Revisions and Errata List
AISC Steel Design Guide 9, 1st Printing (Printed Copy)
September 10, 2019

The following list represents corrections to the first printing of AISC Design Guide 9, *Torsional Analysis of Structural Steel Members*.

102

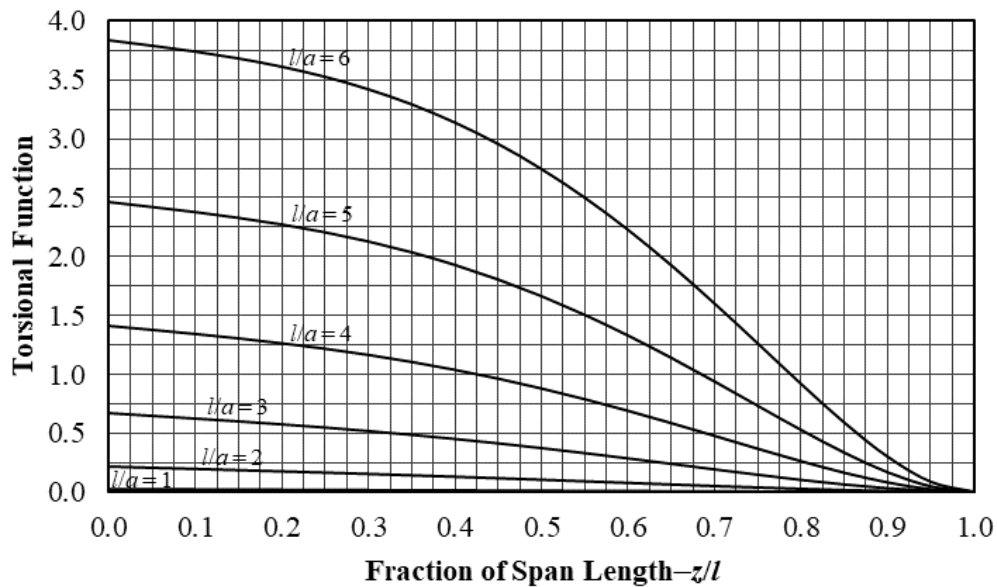
Replace the top graph for $\theta \times \left(\frac{GJ}{t} \times \frac{1}{a^2} \right)$ with:

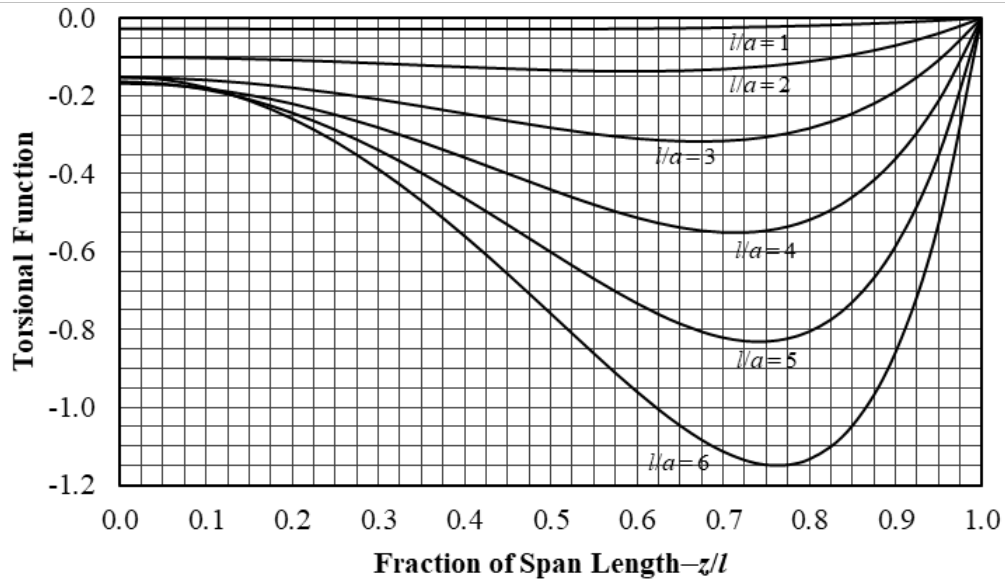
Replace the bottom graph for $\theta' \times \left(\frac{GJ}{t} \times \frac{1}{a} \right)$ with:

103

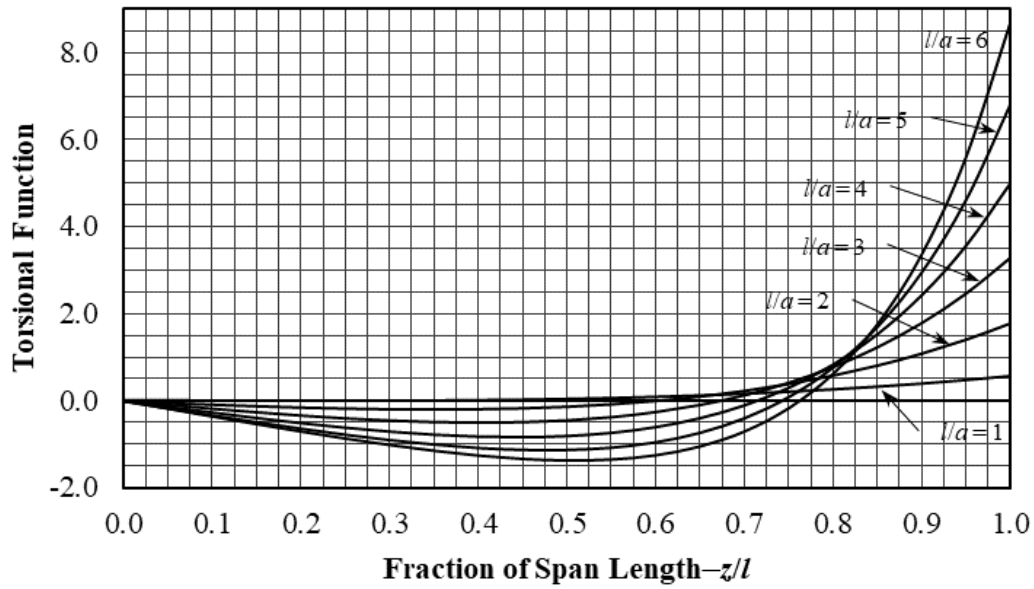
Replace the top graph for $\theta'' \times \left(\frac{GJ}{t} \times 4 \right)$ with:

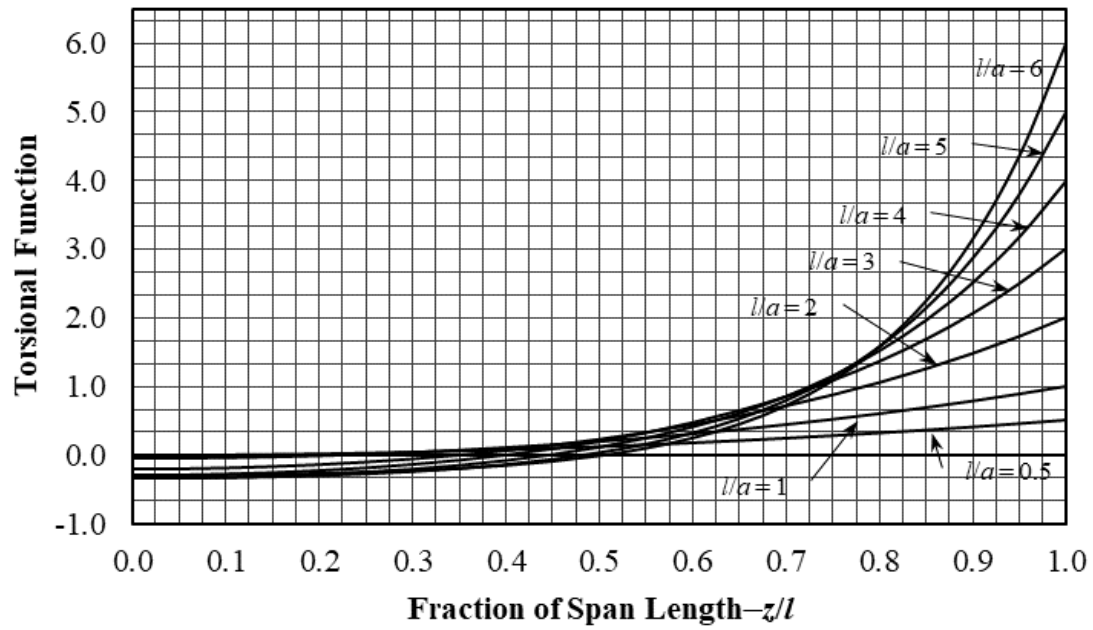
Replace the bottom graph for $\theta''' \times \left(\frac{GJ}{t} \times 2a \right)$ with:
